Peach Bottom Atomic Power Station Unit Nos. 2 and 3  
Facility Operating License Nos. DPR-44 and DPR-56  
NRC Docket Nos. 50-277 and 50-278

Subject :    Addendum to Radiation Dose Assessment Report No.23, January 1,2007  
                  through December 31, 2007

**Addendum to Radiation Dose Assessment  
Report No. 23**

Figure B-3  
 Environmental Sampling Locations Greater Than  
 Five Miles from the Peach Bottom Atomic Power Station, 2007

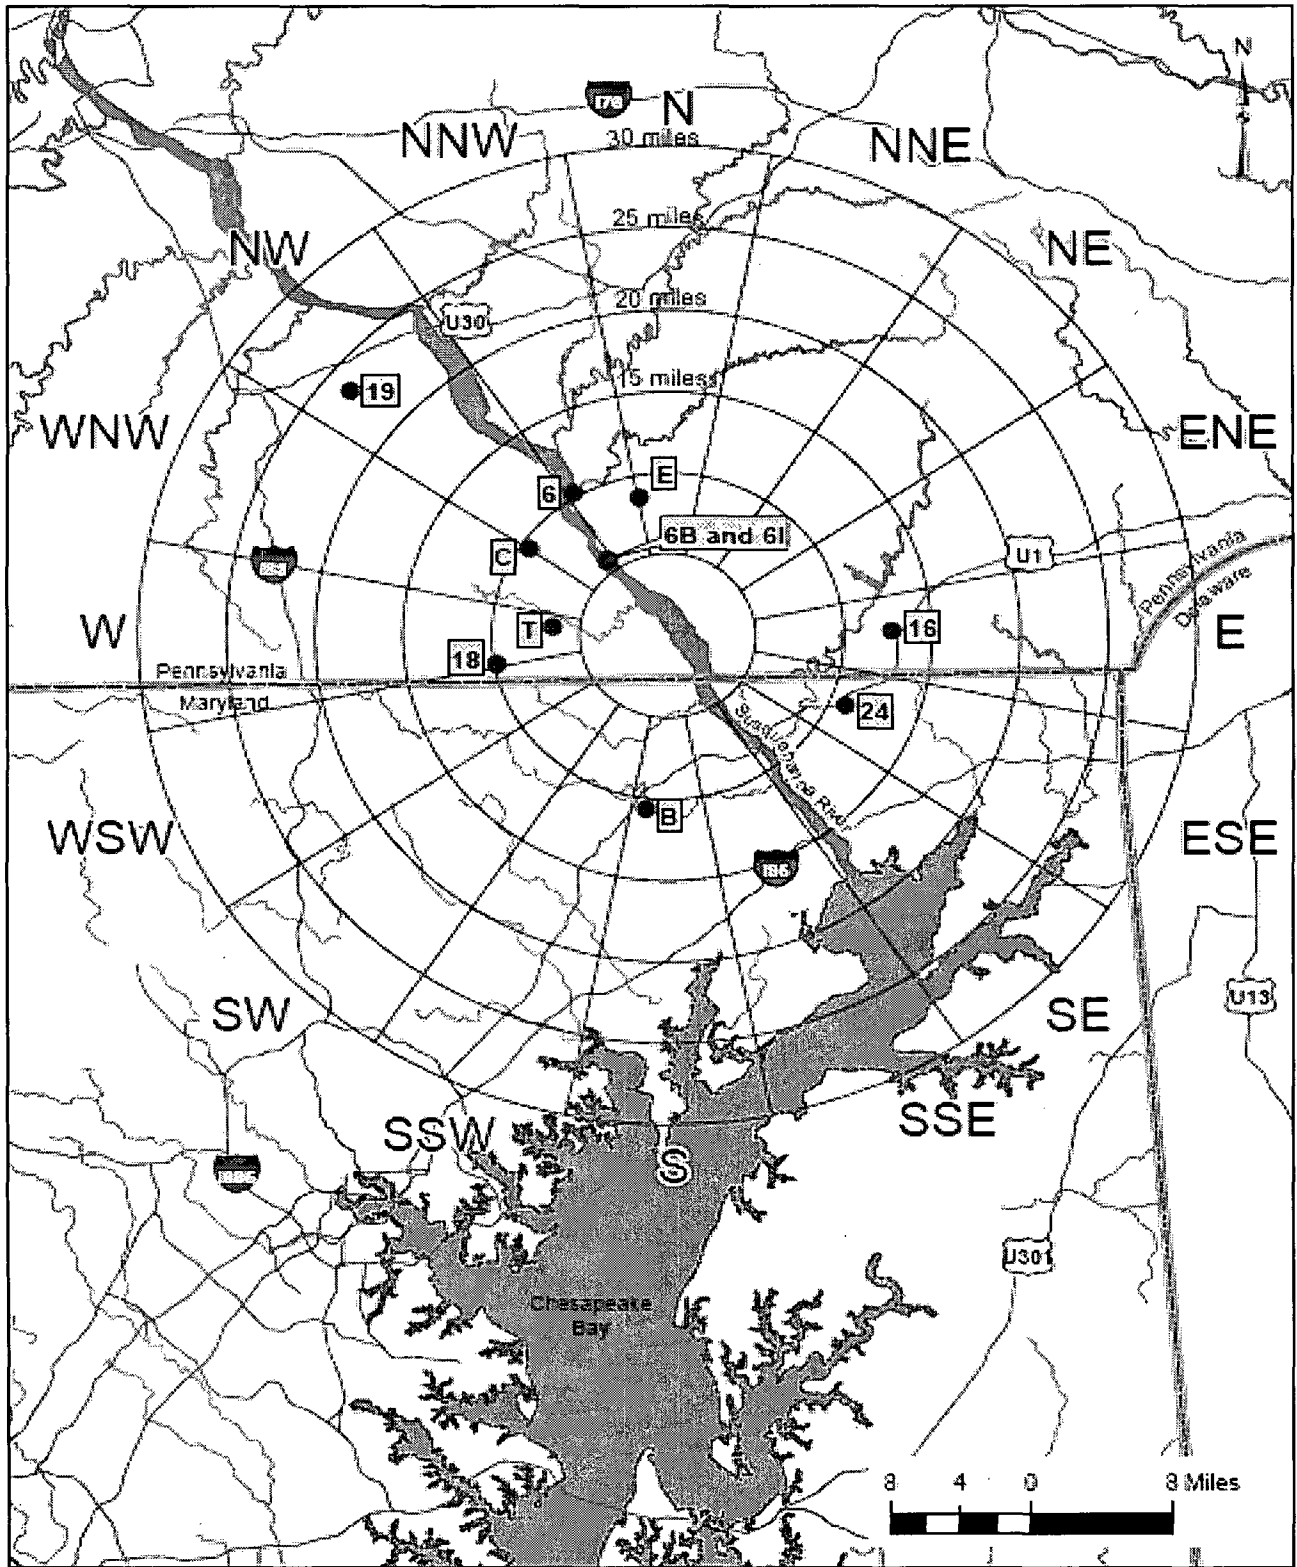
Please see attached Addendum to the Radiation Dose Assessment Report No.23.  
FIGURE VII.A.3 "Environmental Sampling Locations Greater Than  
Five Miles from the Peach Bottom Atomic Power Station, 2007" was corrected to  
indicate Farm T being located in the W sector versus the WSW sector in the original  
submittal
